Project **Lakeshore Lodge LTC – Level 4 Servery**

March 27, 2024

End of Addendum 7

DRAWING NO.
QF-100

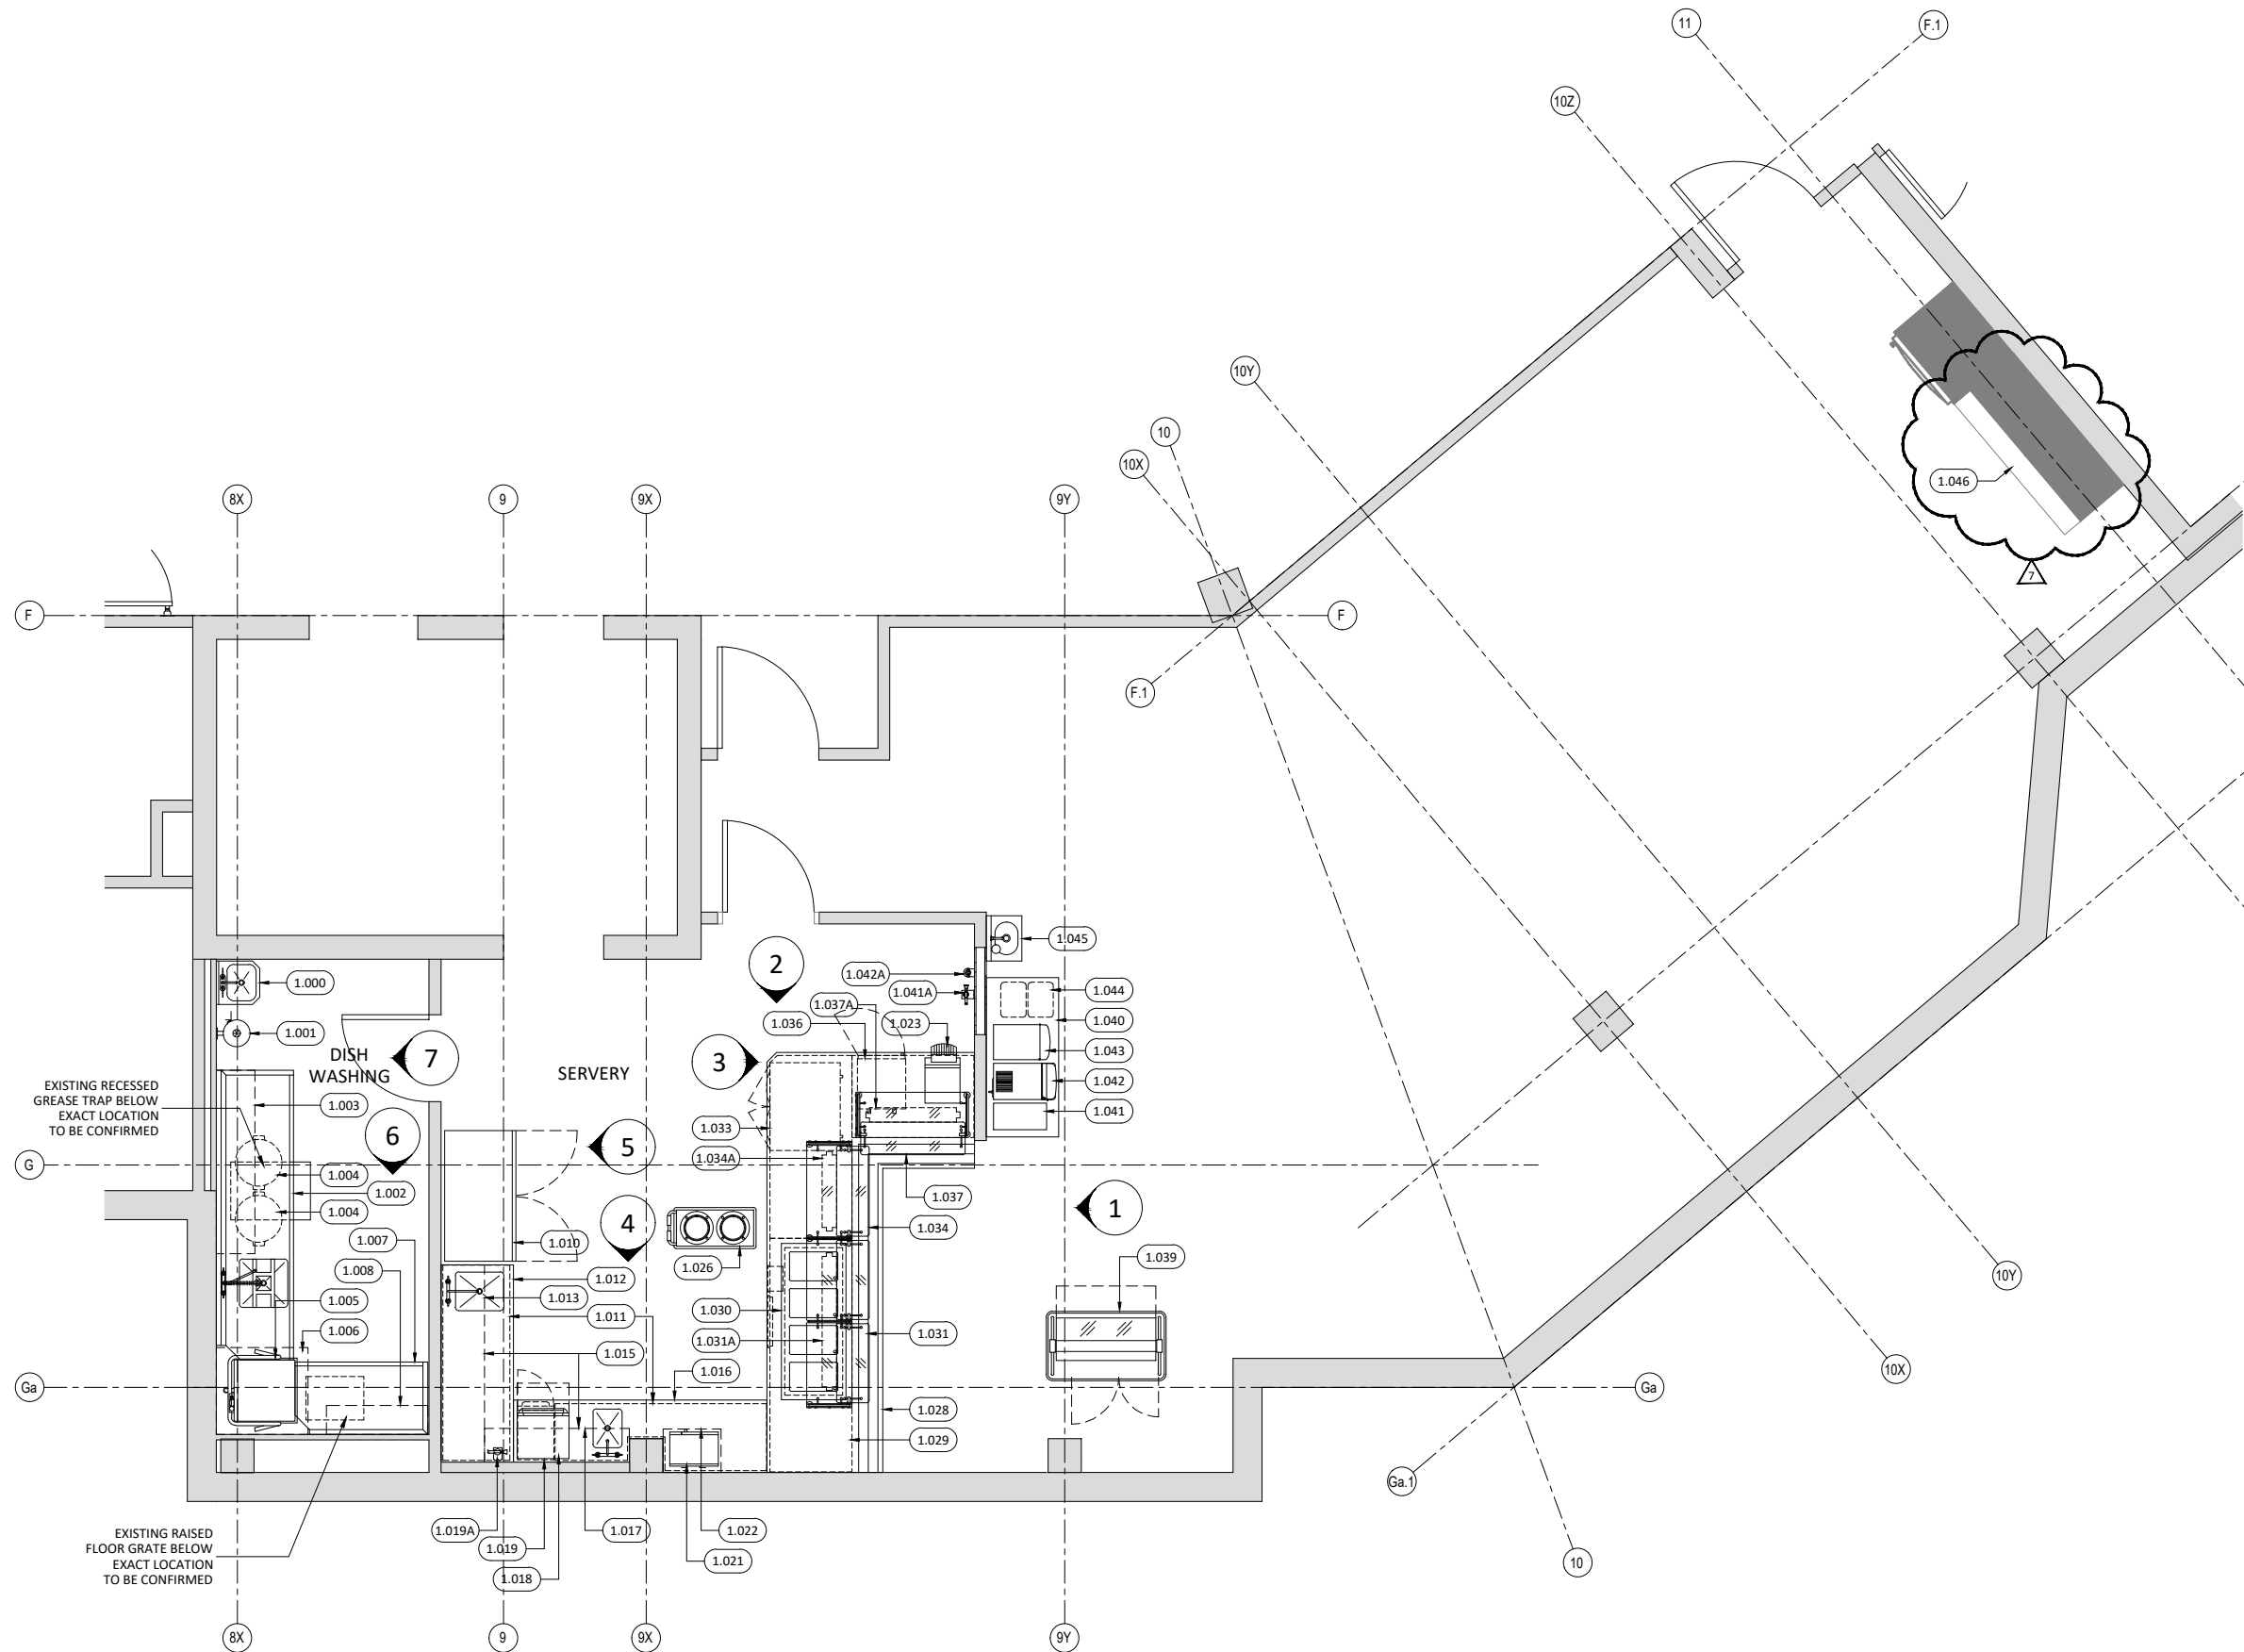
1. Add the following item to the Level 4 Servery.

ITEM NO. 1.046: NEW S.S. COUNTERTOP

Quantity: One (1) – by K.E.C.
Nominal size: 1,825mm long x 826mm wide
Type: Custom fabricated s/s construction in accordance with the specification for this section.

- 14 ga. stainless steel top with 38mm high boxed edges on front and right-hand side. Refer to QF drawing Detail 400 for edge profiles.
- K.E.C. to verify dimensions on-site prior to fabrication.
- K.E.C. to coordinate stainless steel countertop installation requirements with millwork fabricator, including base cabinet wood subtop and supports provided by millwork contractor.
